Taharat Composite Ltd. (Extension) (previously Fabrica Knit Composite Ltd)

26 December 2023

Structural Inspection Report

Typical floor load plan

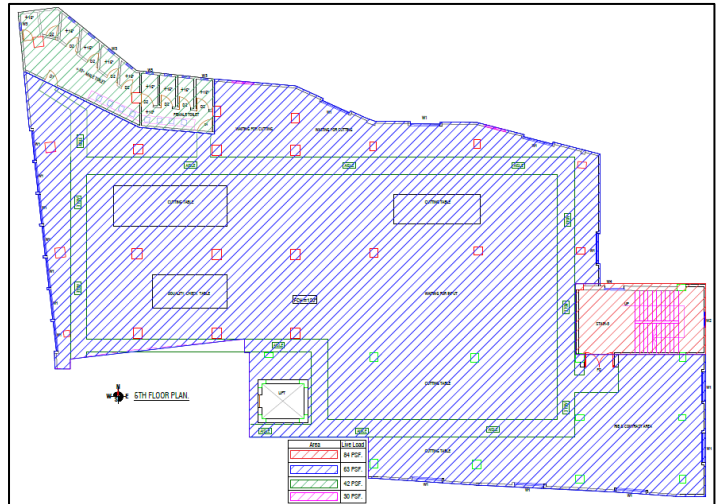
Description: Live load on the finished goods storage area of the 1st and 4th floor is considered as 3 kPa in the prepared load plan. As per BNBC-2006, live load for light storage areas is required to be considered minimum 6 kPa. Therefore, the factory engineer is required to revise the load plan as per BNBC requirements and check the design accordingly.
